# Stormwater Servicing Report

Marsfield Common

Ref: 212044  
Rev: G  
Date: 10.05.2022

## **RESPONSE TO CITY OF RYDE LETTER DATED 31 MARCH 2022**

DRAWING TITLE
CIVIL DESIGN
Yangalla Diversion v1

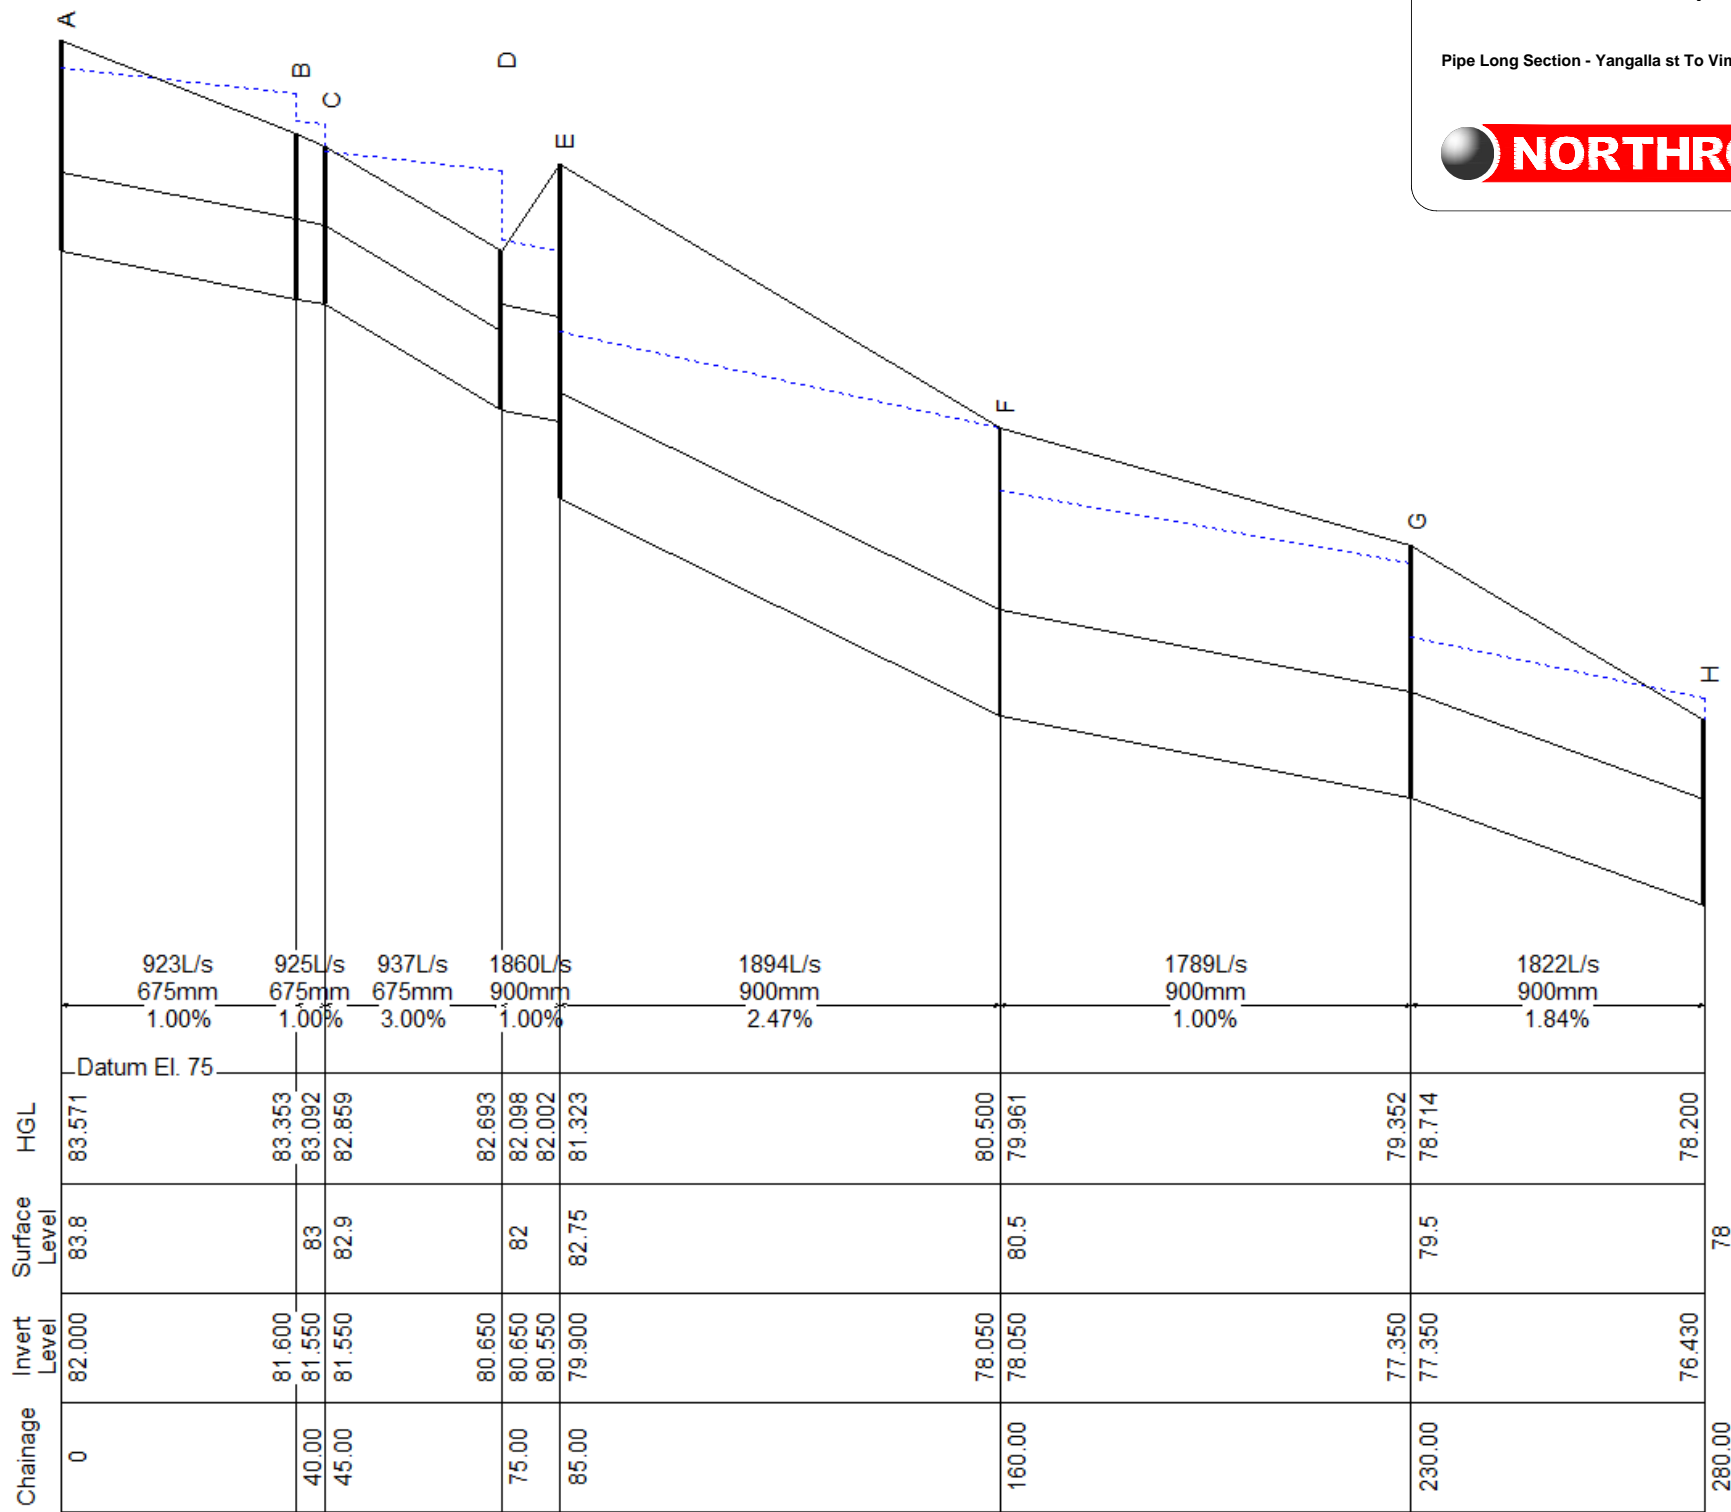
- *Explore the construction of a stormwater pipe (with enough KIPs to collect all runoff) in Yangalla Street to collect the overland flows to ensure it does not reach the development site.*
- *If overland flows are proposed through the site, every dwelling affected by overland flow may have to be built on piers, to allow free pass of the overland flows (no concentration of flows will be supported).*

See section title "Channel for Upstream Catchment Flows" on Page 15 under Stormwater Strategy for full response and explanation. Northrop has explored the potential, through modelling, of different options to mitigate the usage of a channel through the proposed lots, such as installation of pipe in Yangalla Street. This resulted in running pipes against grade and through the crest of a road and was deemed not feasible. It was determined that the most effective solution in dealing with upstream catchment flows was to install a fenced off channel.
